## ASOS MODIFICATION NOTE 33 (for Electronics Technicians)

SUBJECT : ACU Memory Firmware Version 2.4 and ACU CPU Firmware 1.81

PURPOSE : Firmware for Meteorological Aviation Report (METAR).

EQUIPMENT AFFECTED : ASOS Acquisition Control Unit (AACU)

FIGURE 1

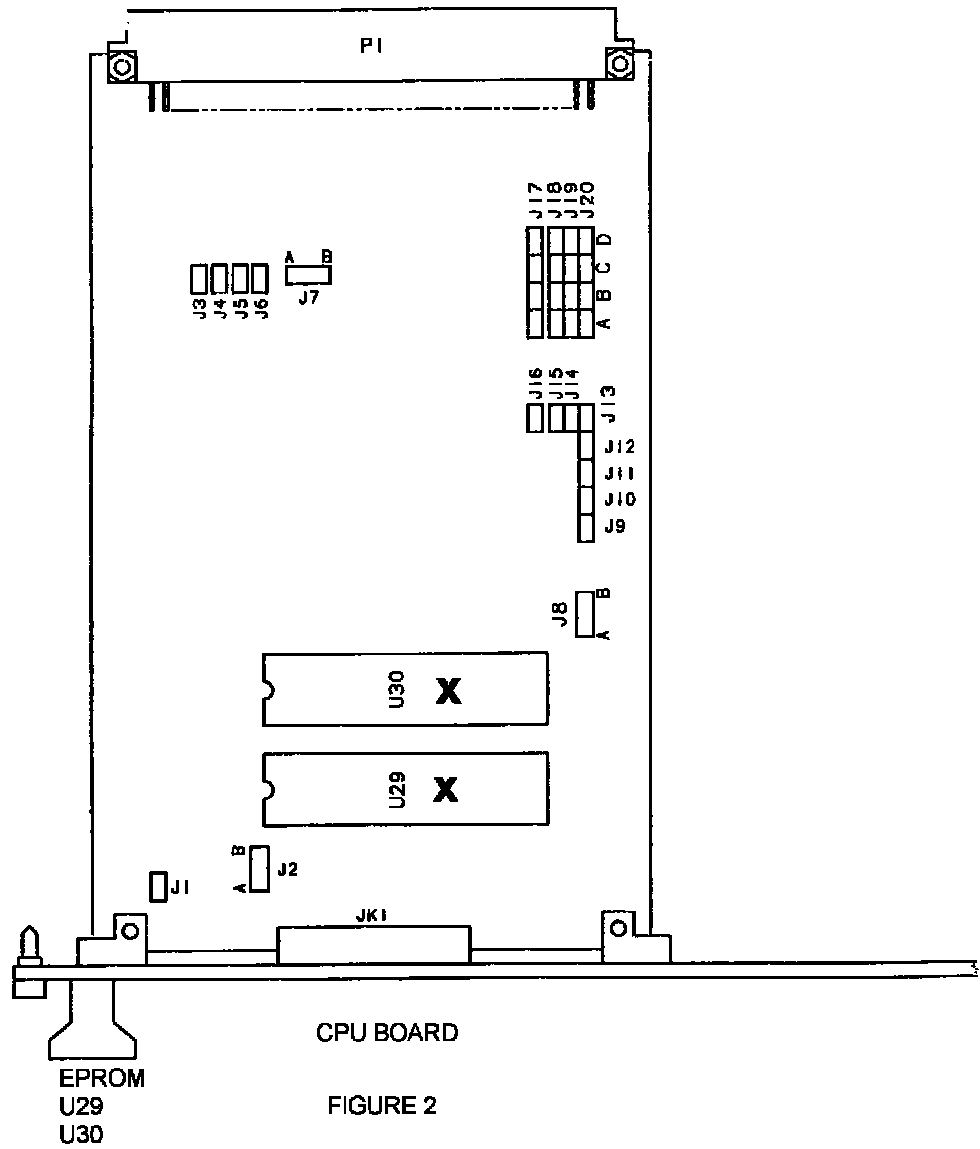
All ASOS application software is contained on the four erasable programmable read only memory (EPROM) integrated circuits (IC) on ACU memory board 1A2A3. Figure 1 illustrates the ACU memory board and identifies the four EPROMs (U8, U17, U7, and U21). The EPROMs are 32-pin dual in-line package (DIP) CMOS devices, each providing 512K x 8 bits of storage. Upgrading ASOS software requires only replacing the four EPROMs on the ACU memory board with higher revision level ICs.

Figure 1 also identifies the four additional RAM chips (U46, U47, U52 and U53). The RAM chips are 32-pin DIP CMOS devices, each providing 128K x 8 bits of storage. There will be no jumpers or switch setting changes to the board. **One RAM chip is added to the top of the clock socket/chip (U52). This causes the chip to protrude into the next card slot position.**

11. Using the IC insertion tool, remove the new EPROM ICs from protective packaging and insert them into the ACU memory board sockets in accordance with the following chart. Ensure that the EPROMs are installed with pin 1 (as identified by notch in top of IC) oriented toward board connector P1 and P2 as shown on Figure 1.

12. Step 12 and 13 can be skipped if ACU memory version 2.23 or later has been installed. Using the IC insertion tool, remove the RAM ICs from protective packaging and insert them into the ACU memory board sockets U46, U47, U52 and U53. Ensure that the RAMs are installed with pin 1 (as identified by notch in top of IC) oriented toward board connector P1 and P2 as shown on Figure 1. U52 already has a clock chip installed. **DO NOT REMOVE THE CLOCK CHIP.** Install the RAM chip on top of the clock chip.

<u>IC socket</u>	<u>IC part number</u>
U8	62828-45002-1
U17	62828-45003-1
U7	62828-45004-1
U21	62828-45005-1
